Authorized Field Change

AFC G-01910

Subject: Plugged Power Steering Reservoir Dipstick Vent Hole in 4300 and 4400 Models Built Between April 11, 2001 and May 11, 2001 Manufactured at the Springfield Assembly Plant

Figure 1 Arrow Indicates Label with Date Code

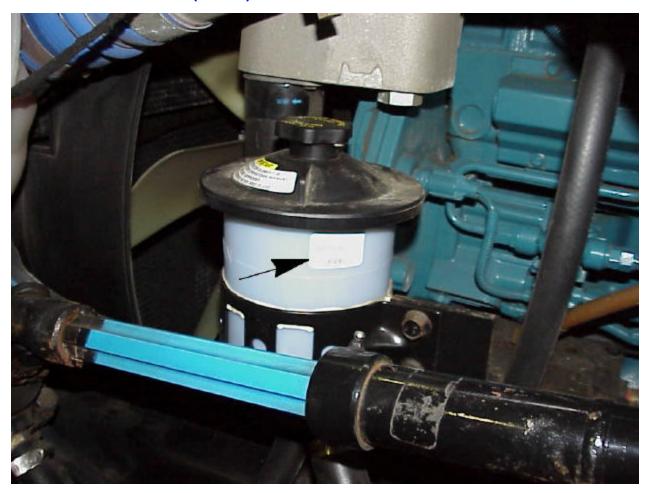
The supplier of the power steering reservoir and dipstick assembly produced dipsticks with partially or completely plugged vent holes.

Inspect the date code on the power steering reservoir (Figure 1). If the date code is "010409" through "010503", replace the dipstick with Part Number 2507059C1.
